World Forum for Harmonization of Vehicle Regulations

Proposal for the 02 series of amendments to Regulation No. 80 (Strength of seats and their anchorages (buses))

Submitted by the Working Party on Passive Safety*

1. Arrangements in the approval mark for a seat

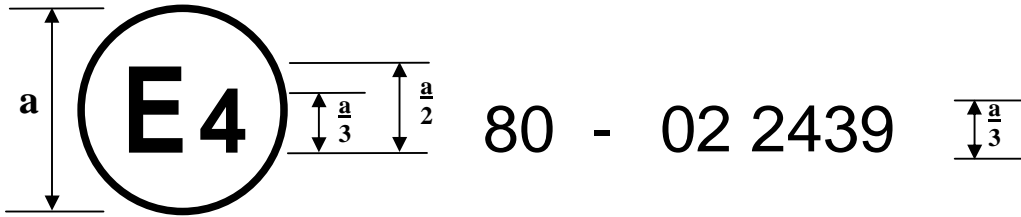
Annex 3, paragraphs 1. and 2., amend to read:

The above approval mark affixed to a seat shows that the seat type concerned has, with regard to the strength of the seats, the test being carried out in accordance with paragraph 2 of annex 4, been approved in the Netherlands (E4) under number 022439. The approval number indicates that the approval was granted in accordance with the requirements of Regulation No. 80 as amended by the 02 series of amendments.

2. Arrangements in the approval mark for a vehicle type

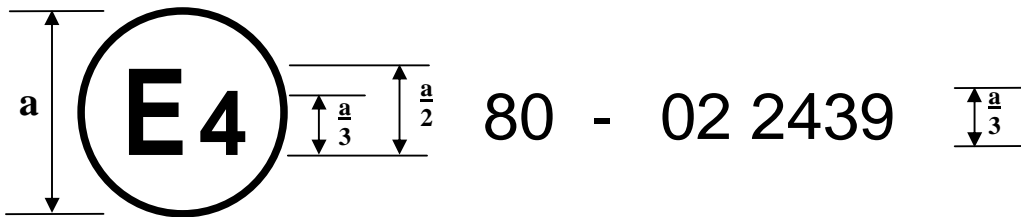
The above approval mark, affixed to a vehicle, shows that this type of vehicle has been approved in the Netherlands (E4) under number 022439 with regard to the strength of the anchorages on the vehicle. The approval number indicates that the approval was granted in accordance with the requirements of Regulation No. 80 as amended by the 02 series of amendments.”
